Thursday, December 04, 2025  
10:00 am.

## SUBDIVISION AUTHORITY AGENDA

### MEETING NO. 48

SUBDIVISION CONDITIONS OF APPROVAL MAP

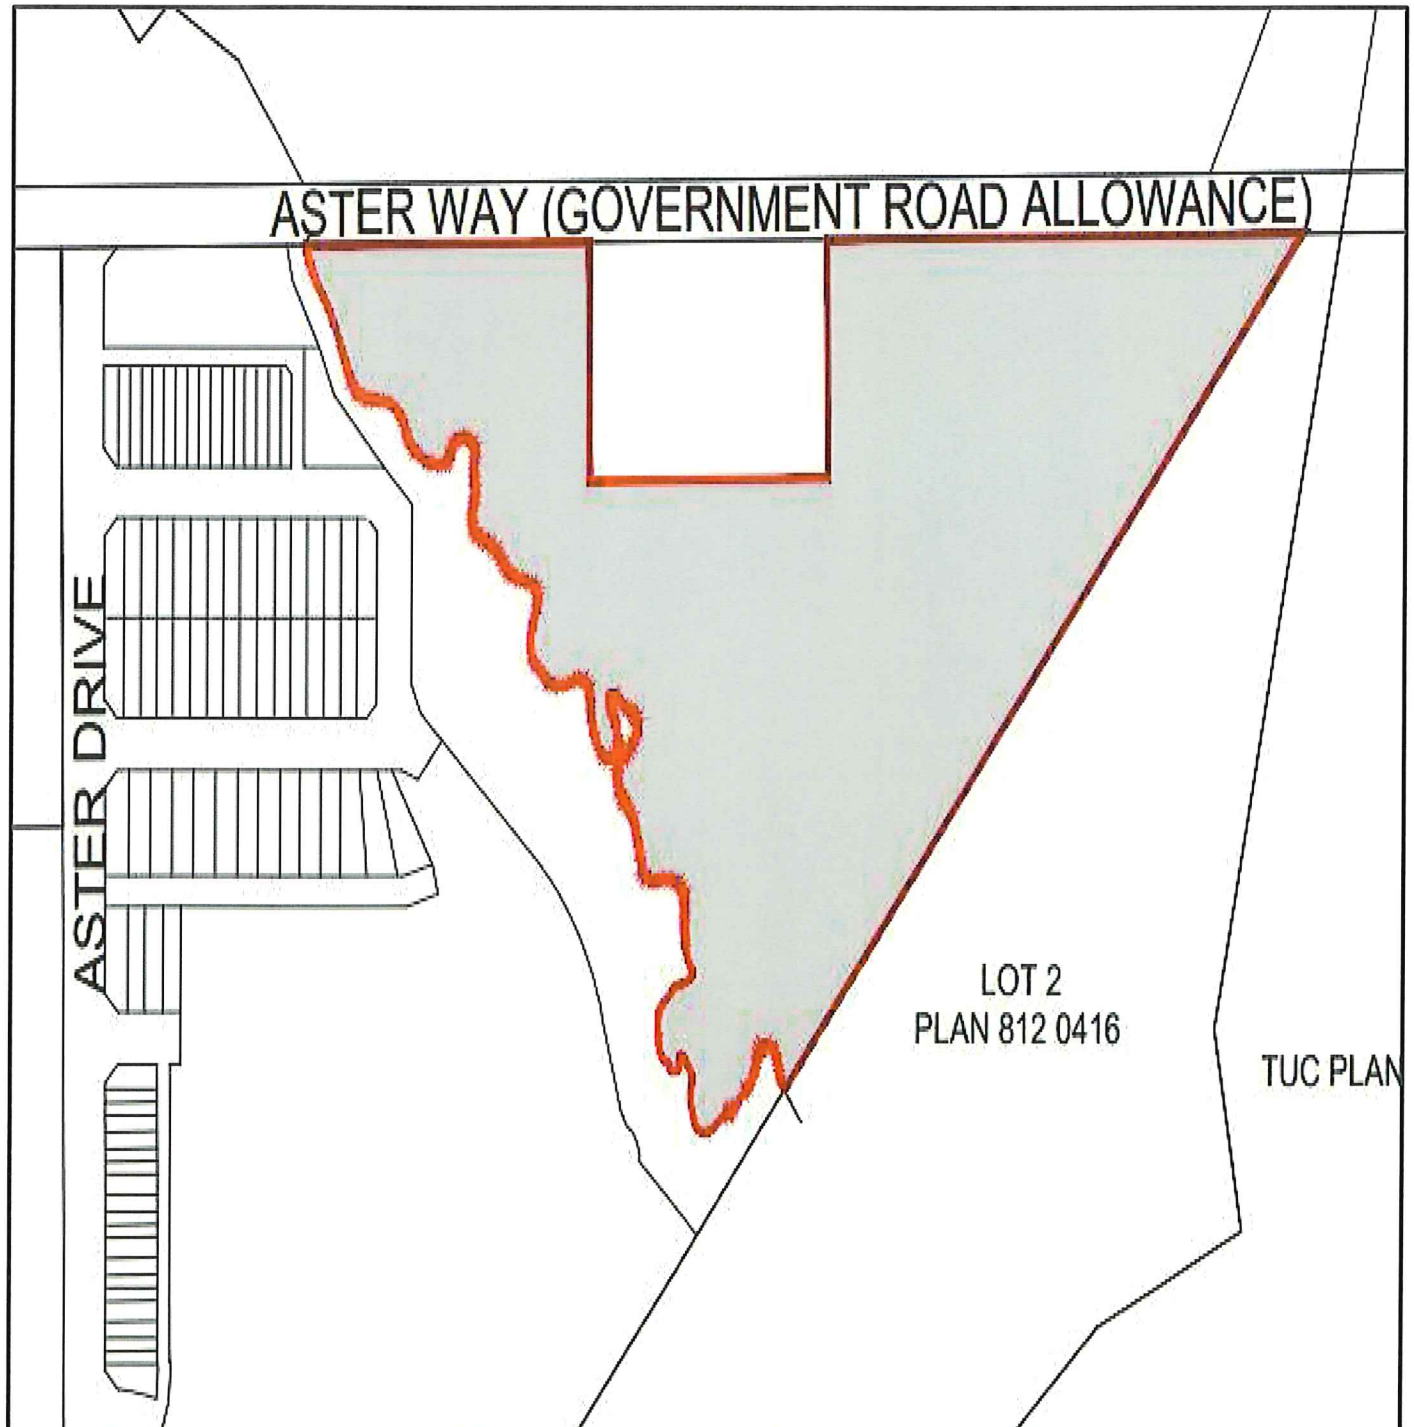
**I The Subdivision by Plan is APPROVED on December 4, 2025, subject to the following conditions:**

1. that the owner pay all outstanding property taxes prior to the endorsement of the plan of survey.

TENTATIVE PLAN SHOWING PROPOSED  
SUBDIVISION

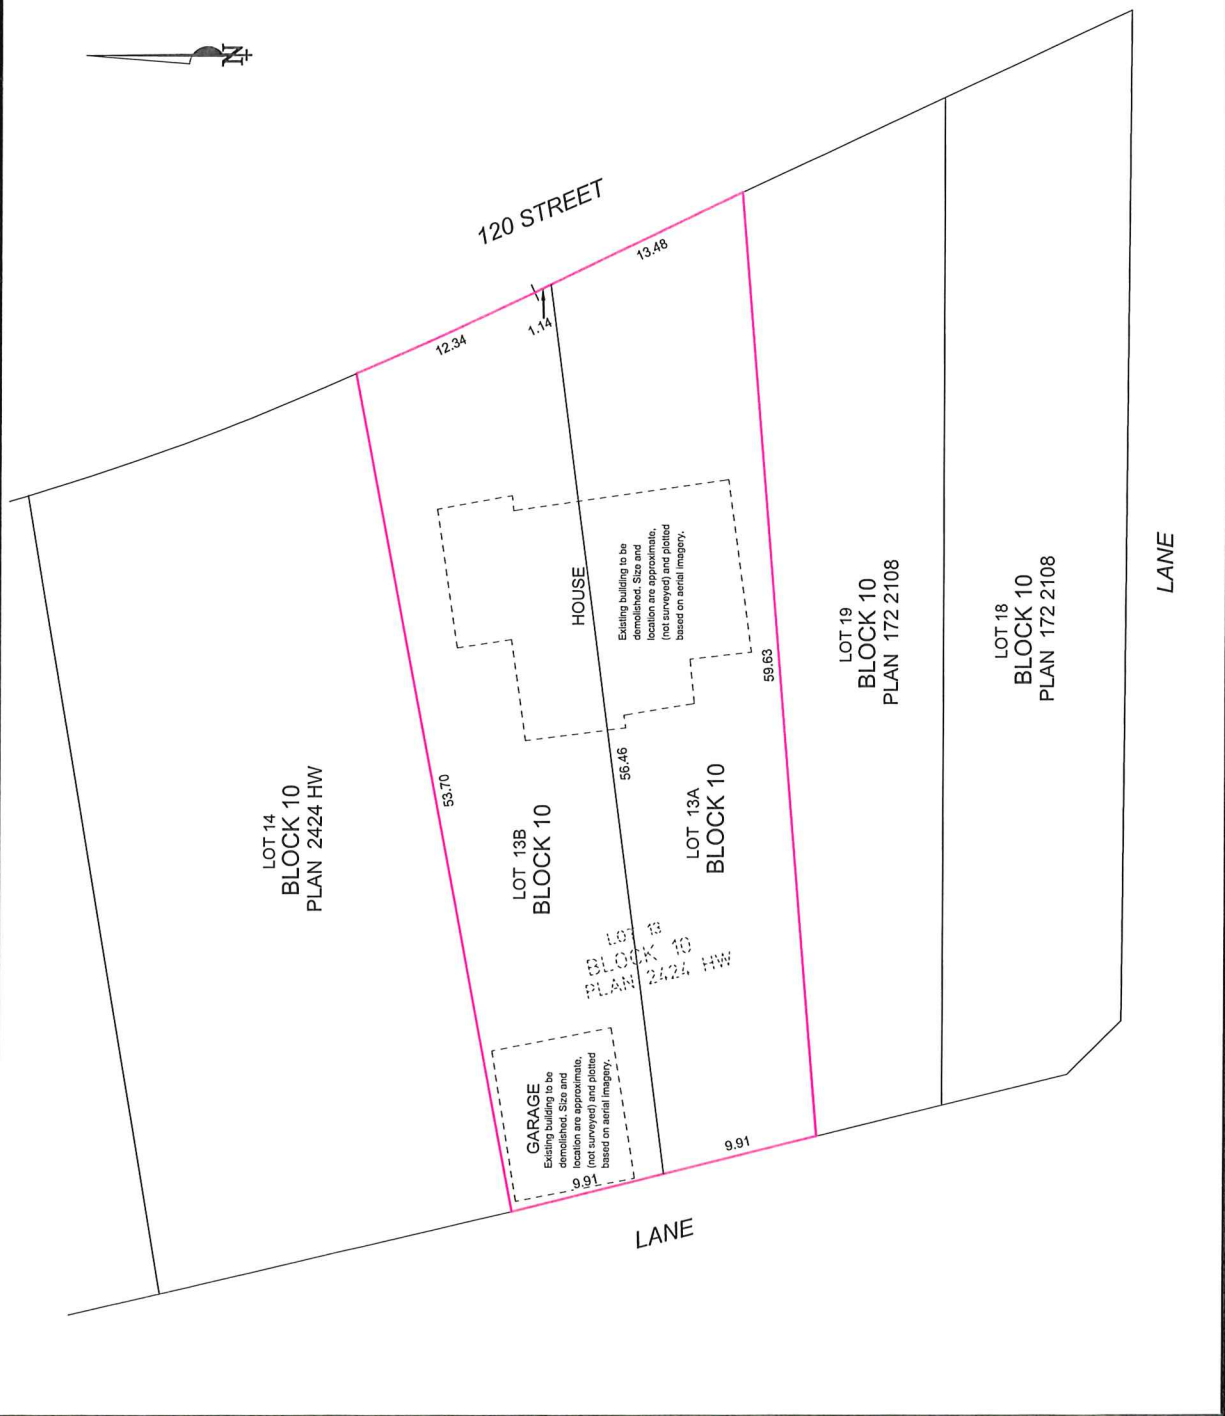
1. that the owner apply for a permit to demolish the existing dwelling and garage prior to endorsement of the final plan. Demolition permits can be obtained from Development Services. Apply online at [www.edmonton.ca/permits](http://www.edmonton.ca/permits); and
2. that the owner pay all outstanding property taxes prior to the endorsement of the plan of survey.

- Access for future development must be to the adjacent alley as per the General Regulations (Section 6.1) in the 2.10 RS - Small Scale Residential Zone of Zoning Bylaw 20001.

- There is an existing driveway access to 120 Street NW. Upon redevelopment of proposed Lot 13B, it must be removed. At that time, the owner/applicant will be required to obtain a Permit for the access' removal from the City's Development Services team. Apply online at [www.edmonton.ca/permits](http://www.edmonton.ca/permits).

- The existing services (water and sanitary) enter the proposed subdivision approximately 9.61 m north of the south property line of existing Lot 13, off the lane. The existing storm service enters the proposed subdivision approximately 41.1m north of EPCOR Manhole #242762 (assumed straight in), off 120 Street NW. As per the EPCOR Drainage Services Bylaw and the EPCOR Water Services and Wastewater Treatment Bylaw, these services cannot cross the proposed property line.

- There is deficient water network capacity adjacent to the property. The applicant/owner is advised to review on-site fire protection requirements to ensure adequate coverage (contact EPCOR Water at 780-412-3955).
- If power service crosses the proposed property line the owner may be required to provide a blanket easement in favour of EPCOR Distribution & Transmission Inc. If required, said easement shall be registered prior to or concurrent with the final plan of survey (contact EPCOR Land Administration Group at 780-412-3252).

# TENTATIVE PLAN

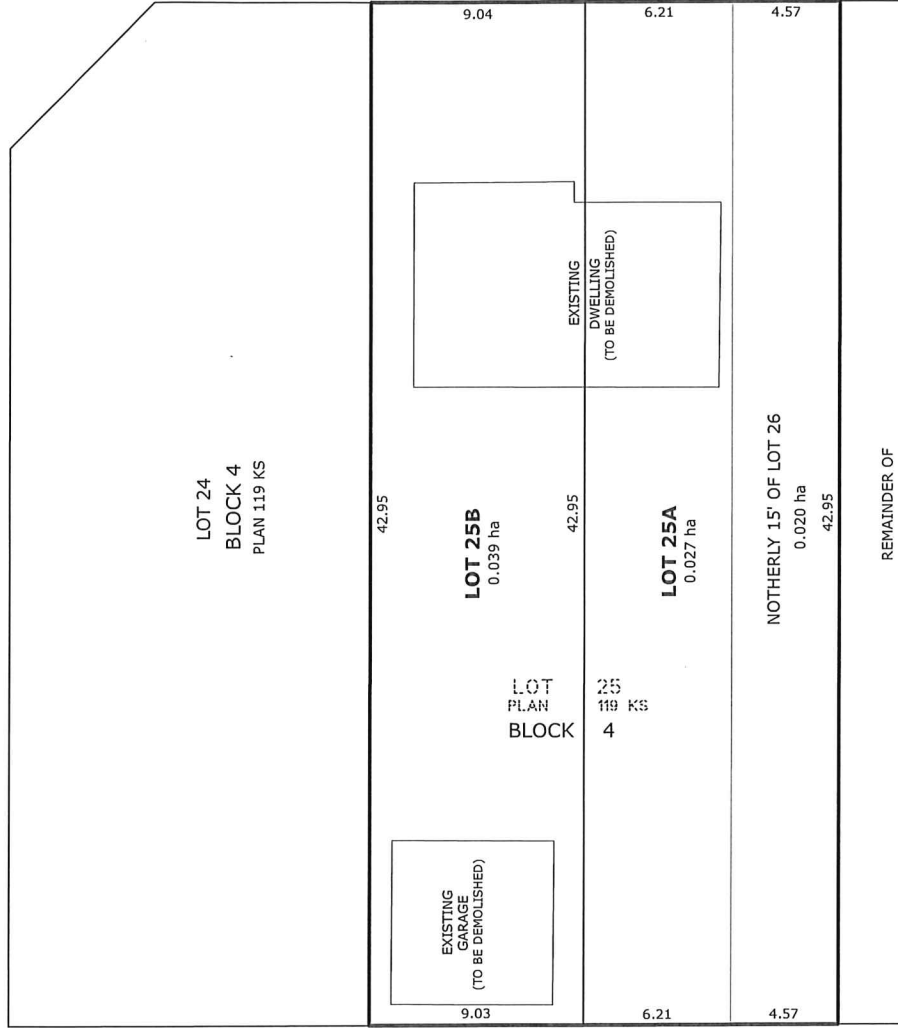
1. that the owner make satisfactory arrangements with EPCOR Water Services Inc. and EPCOR Drainage Services for the provision of separate services (water and sewer) to the proposed south lot;
2. that the owner apply for a permit to demolish the existing dwelling and garage prior to endorsement of the final plan. Demolition permits can be obtained from Development Services. Apply online at [www.edmonton.ca/permits](http://www.edmonton.ca/permits); and
3. that the owner pay all outstanding property taxes prior to the endorsement of the plan of survey.

- The existing services (water and sanitary) enter the proposed subdivision approximately 6.1 m south of the north property line of existing Lot 25, off the lane. The existing foundation service enters the proposed subdivision approximately 6.8 m north of the south property line of existing Lot 25, off 148 Street NW. As per the EPCOR Drainage Services Bylaw and the EPCOR Water Services and Wastewater Treatment Bylaw, these services cannot cross the proposed property line.

TENTATIVE PLAN SHOWING PROPOSED

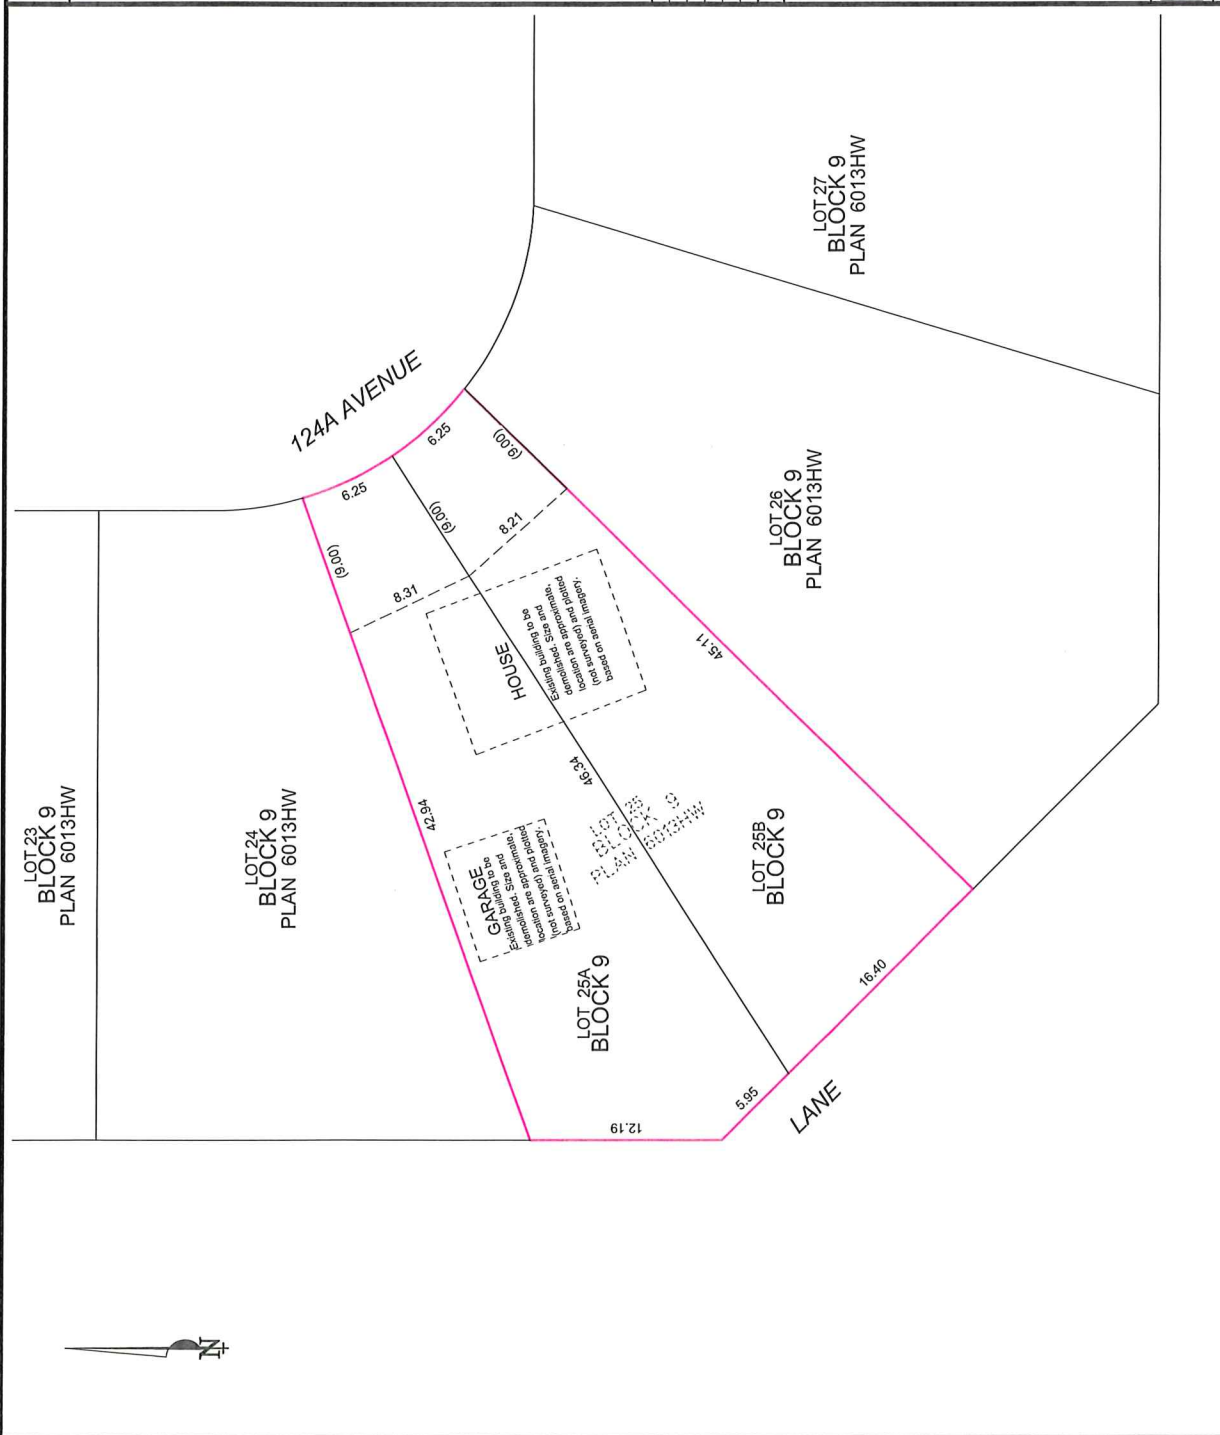
1. that the owner apply for a permit to demolish the existing dwelling and garage prior to endorsement of the final plan. Demolition permits can be obtained from Development Services. Apply online at [www.edmonton.ca/permits](http://www.edmonton.ca/permits); and
2. that the owner pay all outstanding property taxes prior to the endorsement of the plan of survey.

- There is an existing access to 124A Avenue NW. Upon redevelopment of proposed Lot 25A, it must be removed. At that time, the owner/applicant will be required to obtain a Permit for the access' removal from the City's Development Services team. Apply online at [www.edmonton.ca/permits](http://www.edmonton.ca/permits).

- The existing water service enters the proposed subdivision approximately 18.91 m south of the north property line of proposed Lot 25B, off the lane east of 141 Street NW. Existing sanitary service enters proposed Lot 25A approximately 35.3 m north of south of the property line of the lane north of 124 Avenue NW. The existing foundation service enters proposed Lot 25A approximately 3.59 m south of the north property line of existing Lot 25, off 124a Avenue. As per the EPCOR Drainage Services Bylaw and the EPCOR Water Services and Wastewater Treatment Bylaw, these services cannot cross the proposed property line.

- There is a deficiency in on-street hydrant spacing adjacent to the property. The applicant/owner is advised to review on-site fire protection requirements to ensure adequate coverage (contact EPCOR Water at 780-412-3955).
- If power service crosses the proposed property line the owner may be required to provide a blanket easement in favour of EPCOR Distribution & Transmission Inc. If required, said easement shall be registered prior to or concurrent with the final plan of survey (contact EPCOR Land Administration Group at 780-412-3252).
